ADDENDUM NO. 2 TO PROJECT NO. 47552

ELECTRICAL WORK UPGRADE ELECTRONIC SECURITY SYSTEMS VALLEY RIDGE CIT 274 CHIARINO DRIVE NORWICH NY 13815

November 20, 2024

MARK	DATE	DESCRIPTION
⚠	11/19/2024	ADDENDUM 2
	7/26/2024	BID DOCUMENT
PROJECT NUMBER:	47552 - E	
DESIGNED BY:	MJP	
DRAWN BY:	MJP	
FIELD CHECK:		
APPROVED:	NCH	
SHEET TITLE:	SITE CAMERA POLE CSA CABINET DETAILS	
DRAWING NUMBER:	E-613

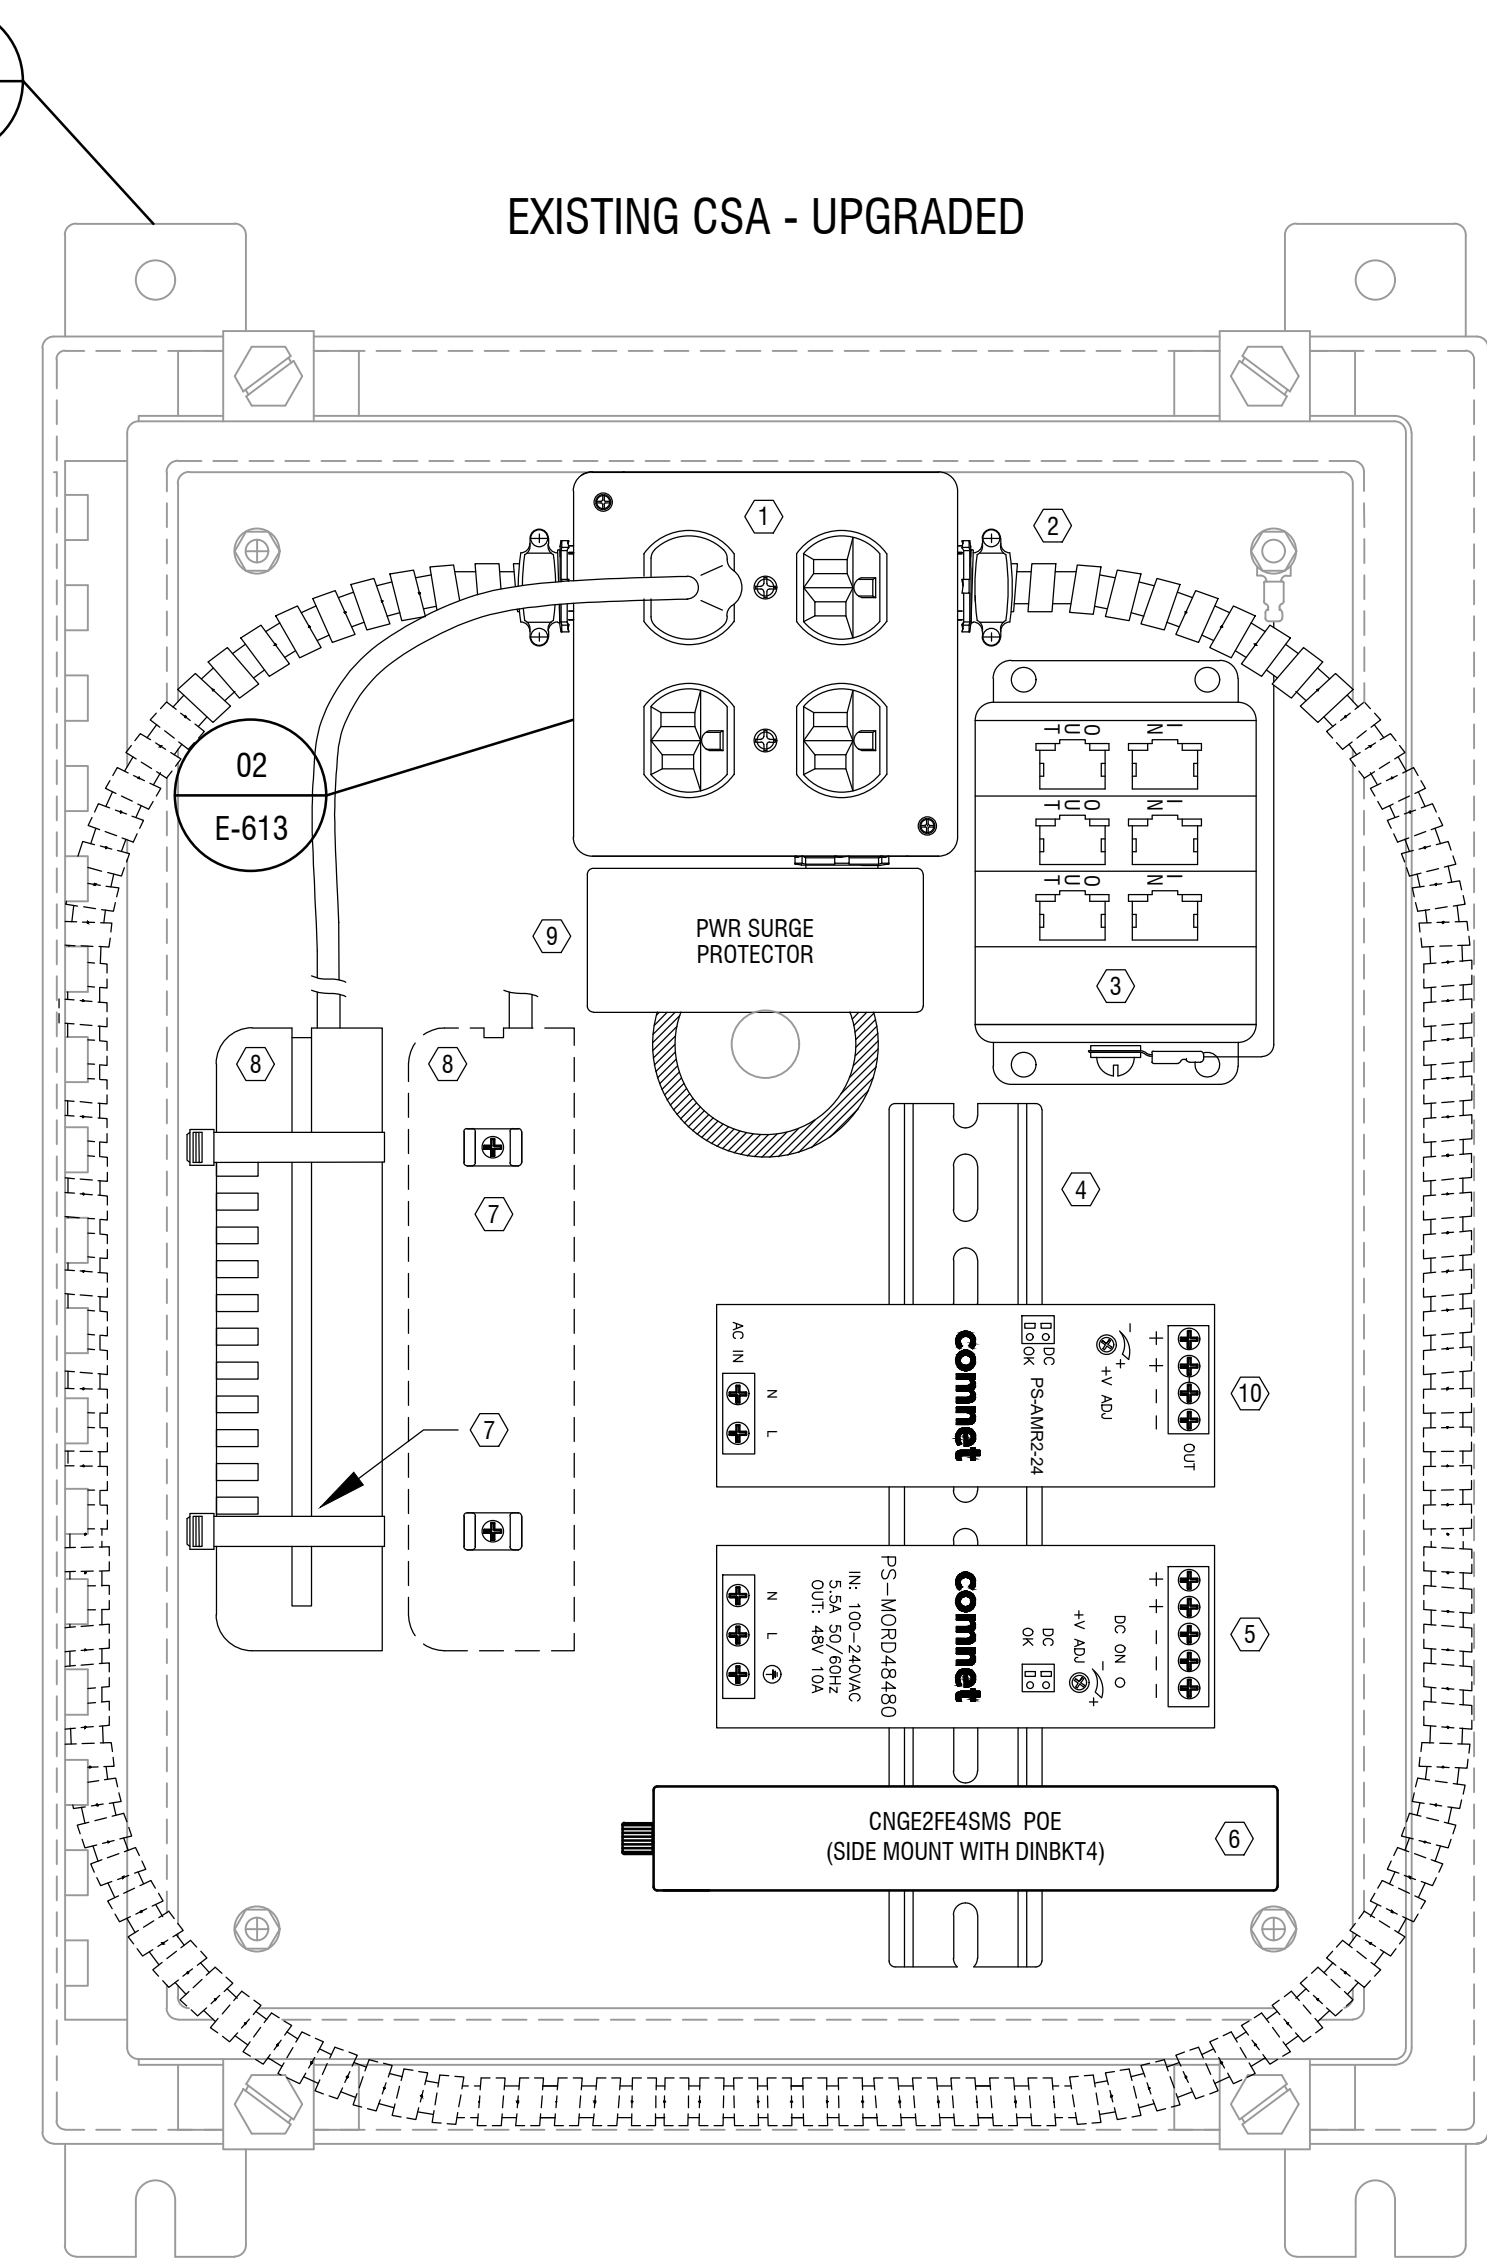
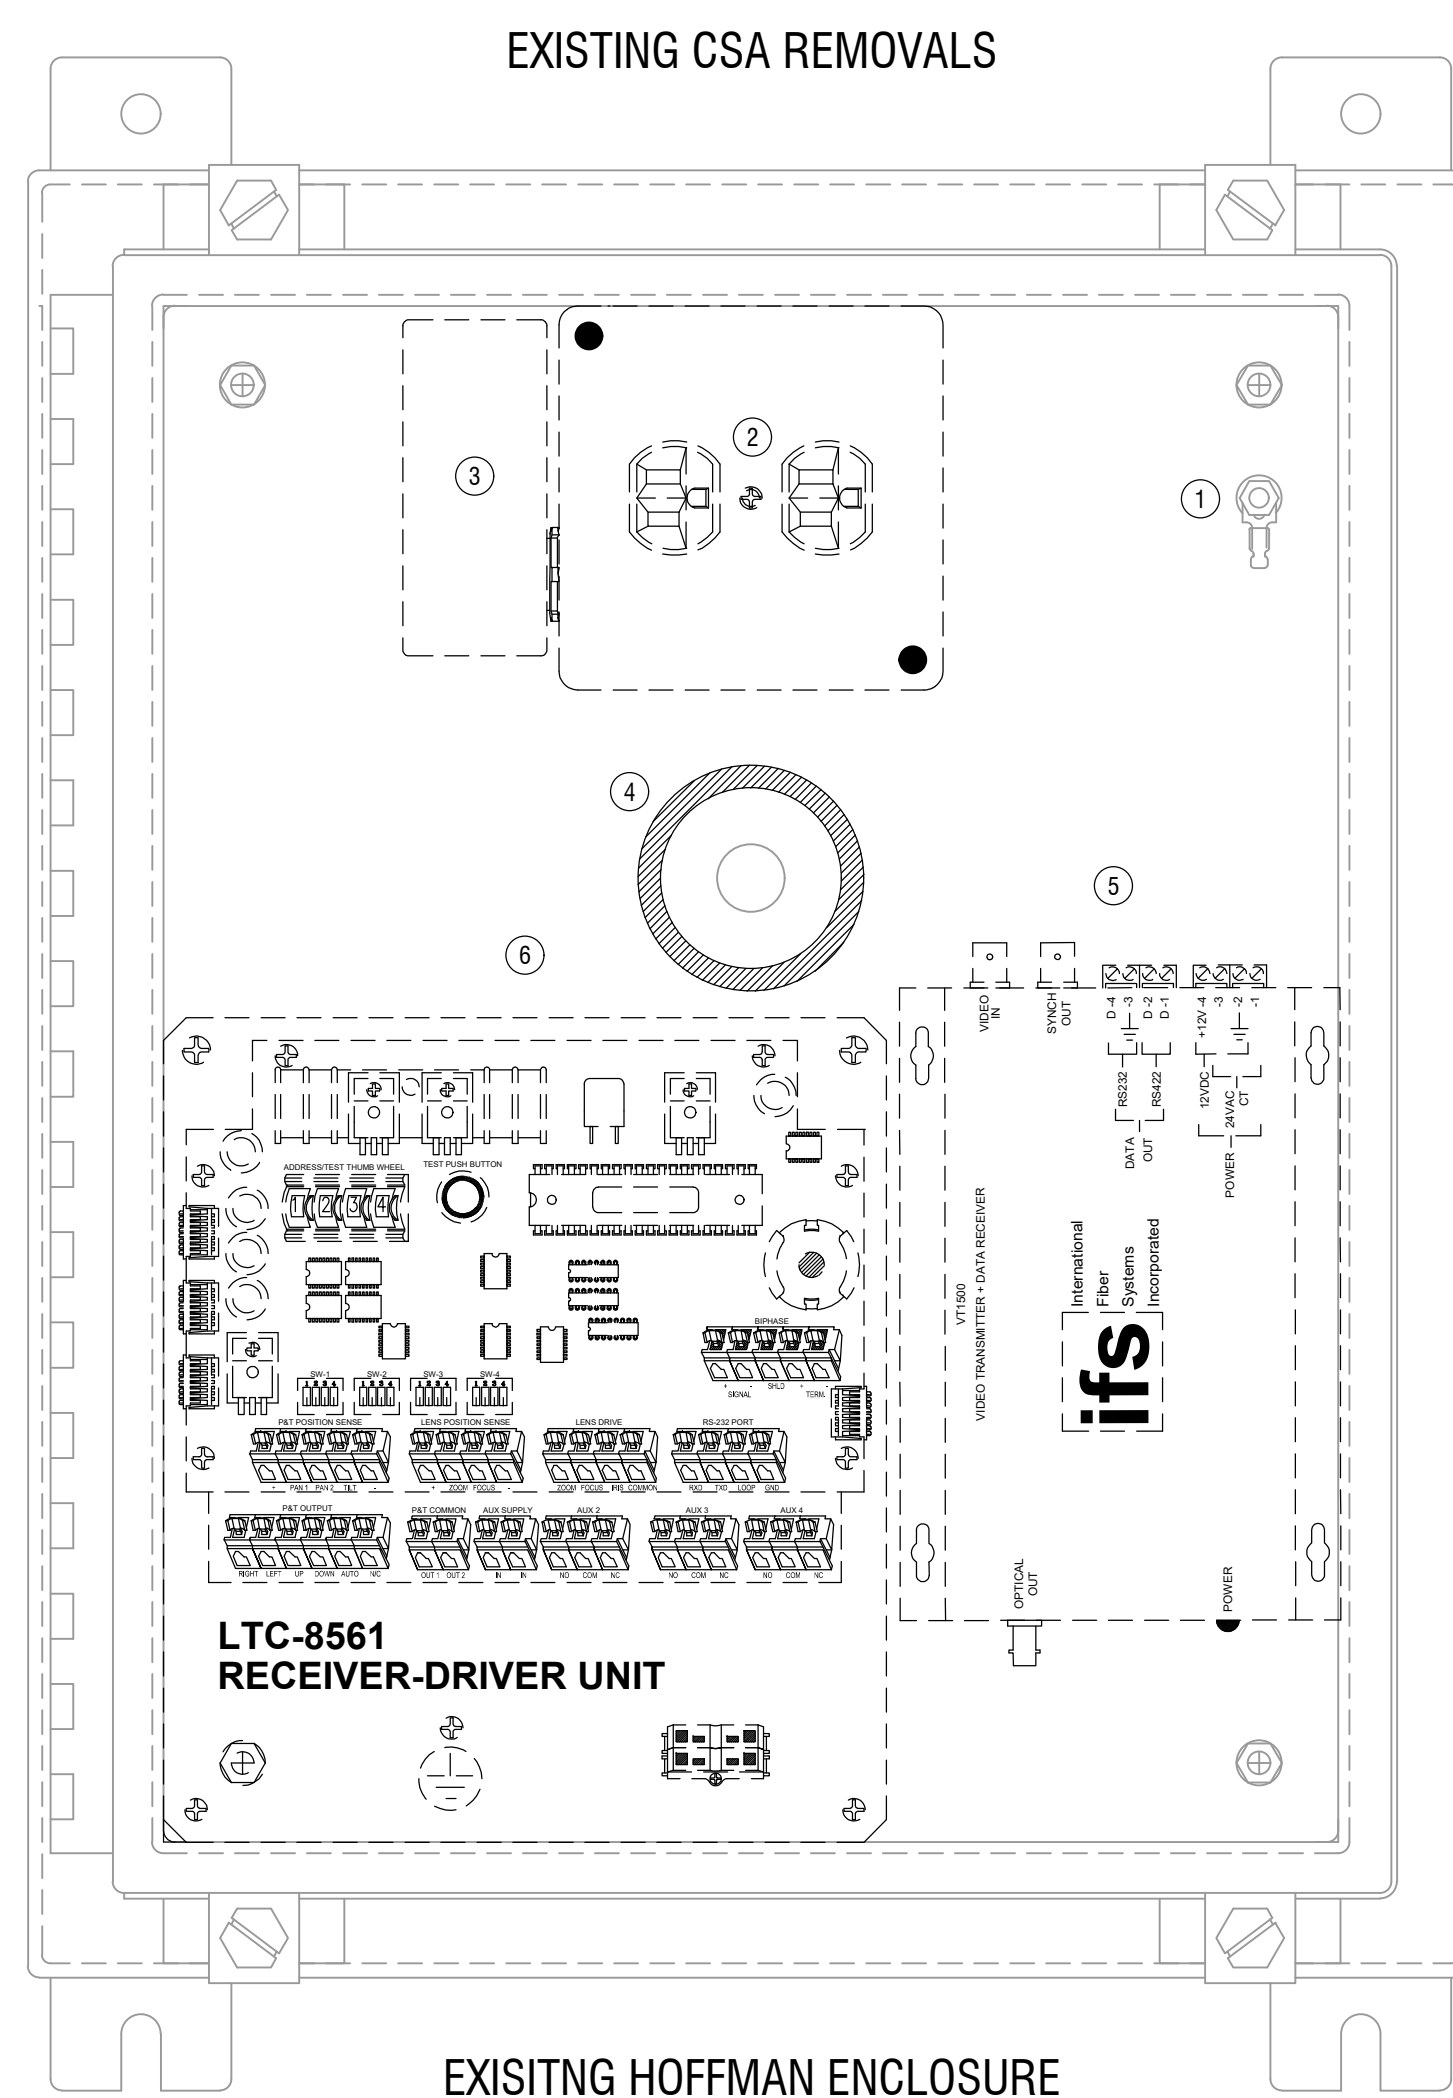
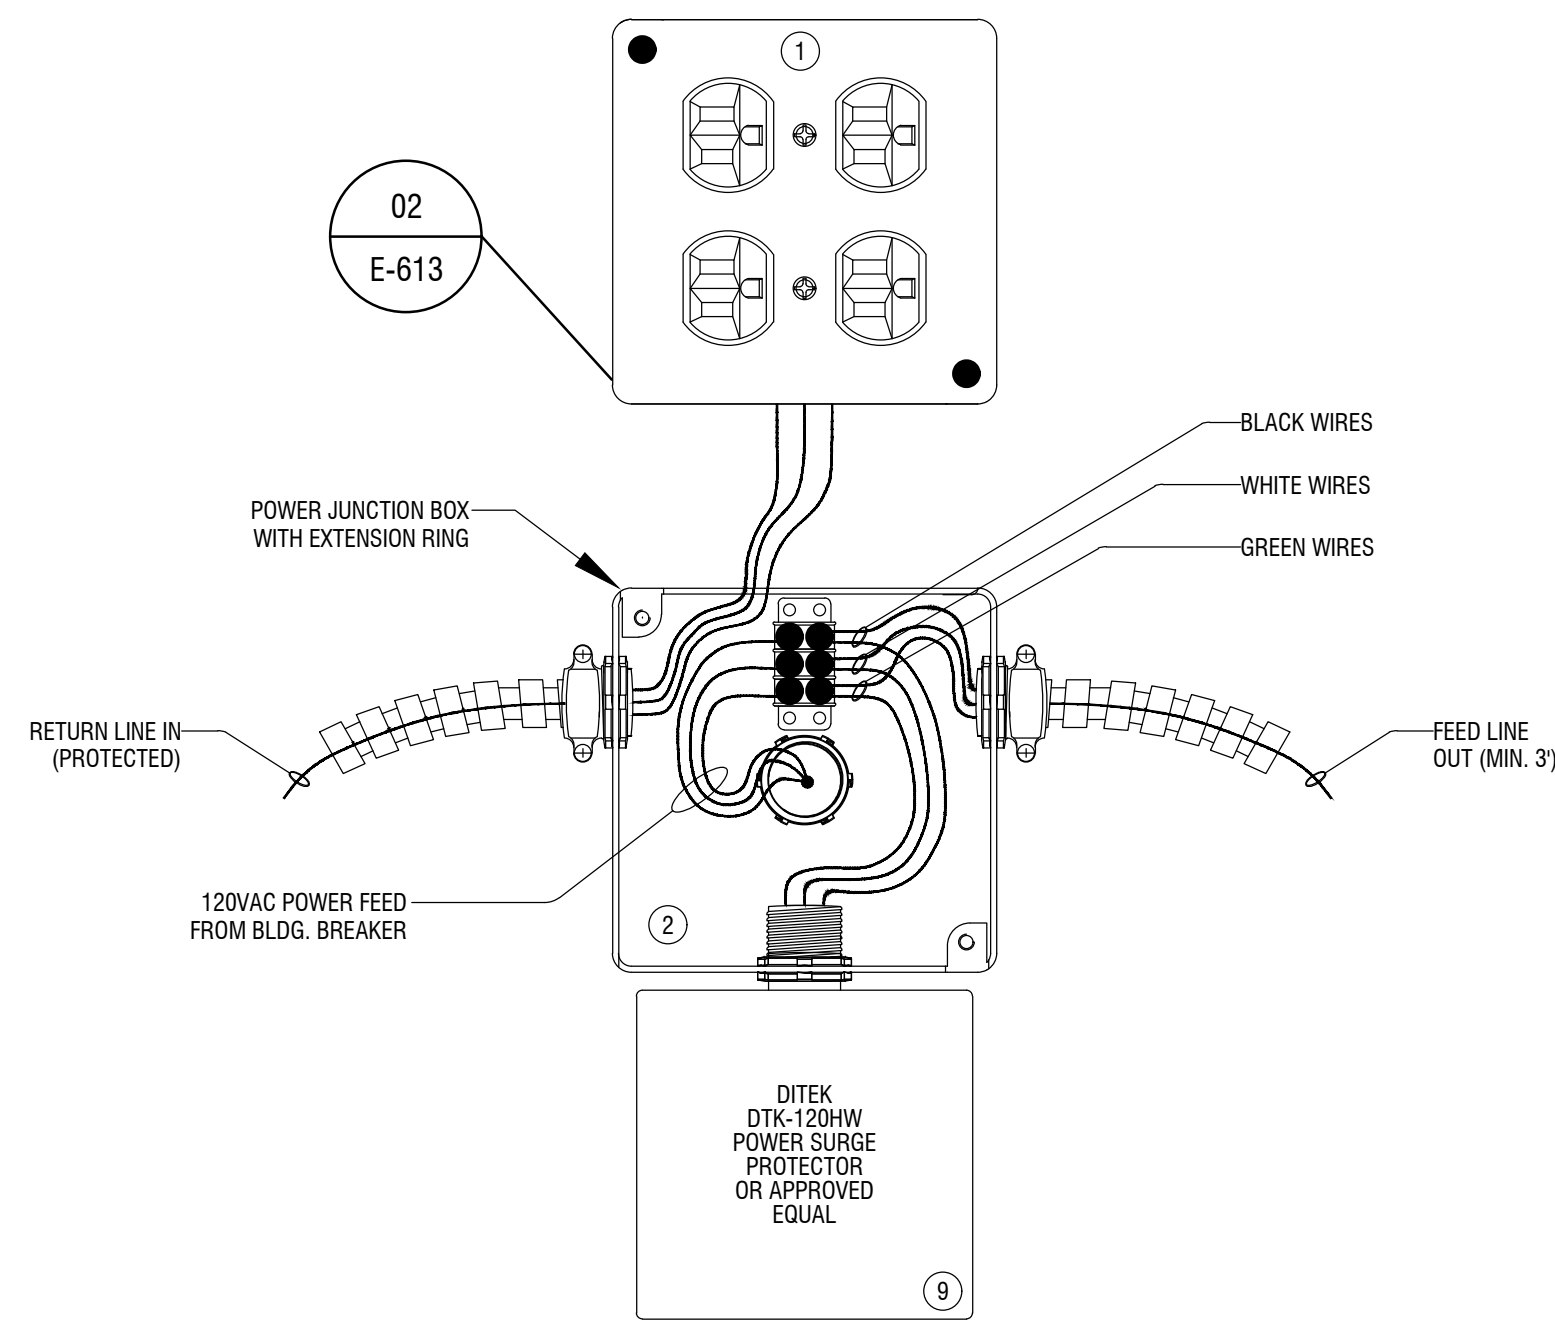
- ① REMOVE EXISTING SINGLE DUPLEX RECEPTACLE AND REPLACE WITH A DOUBLE DUPLEX. ADD 4"x4"x1-1/2" EXTENSION RING FOR CABLING CLEARANCE.
- ② USING THE EXTENSION RING, RUN A 14/3 SOLID BX CABLE AROUND THE INSIDE OF THE ENCLOSURE NO LESS THAN 3". REFER TO POWER SURGE SUPPRESSION DETAIL.
- ③ PROVIDE DITEK DTK-WM4NETS POE SURGE PROTECTOR WITH A MINIMUM OF 2 ACTIVE PORTS.
- ④ PROVIDE 9" 35mm DIN-RAIL CHANNEL.
- ⑤ PROVIDE COMNET PS-MORD48480 POWER SUPPLY FOR NETWORK SWITCH.
- ⑥ PROVIDE COMNET CNGE2FE4SMS NETWORK MODULE. MOUNT SIDWAYS USING THE DINBRK4 MOUNT.
- ⑦ PROVIDE FOUR SCREW DOWN TIE-WRAP HOLDERS. SPACE APPROX. 2" HORIZONTAL AND 4" VERTICAL.
- ⑧ PROVIDE AVIGLON POE-INJ2-95W-NA POWER INJECTOR. RESERVE SPACE FOR 2ND OR FUTURE UNIT.
- ⑨ PROVIDE DITEK DTK-120HW POWER SURGE SUPPRESSOR.
- ⑩ PROVIDE COMNET PS-AMR2-24 POWER SUPPLY FOR ELPAS ELC ANTENNA.
